PLOT PLAN DRAWING

PROJECT NAME: 5930 Pacina Ct.
 SUBMITTAL DATE: 5/10/2018
 SUBMITTED BY: A Martin
 SUBMITTAL REVIEWED BY: _____

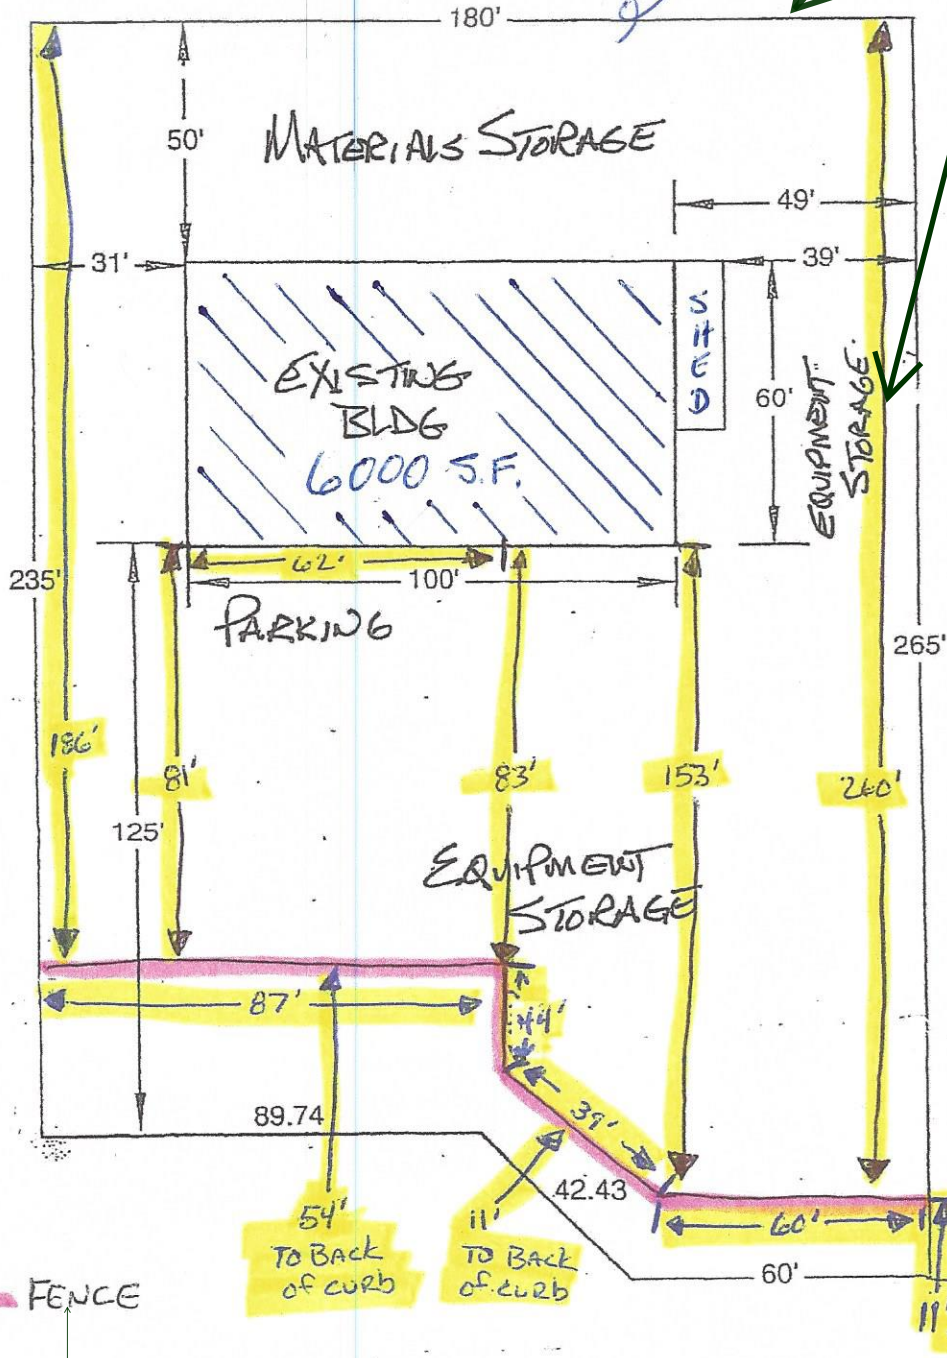
Needs Screening

Show easements.
 Outdoor storage must be screened 100% either by 6' fence, wall, or landscaping.
 Outdoor storage not to exceed height of screening, if it does it is to be placed in the rear 1/3 of the property. (Land Development Code 5.2.38 - Outside Storage)

How tall is the fence?
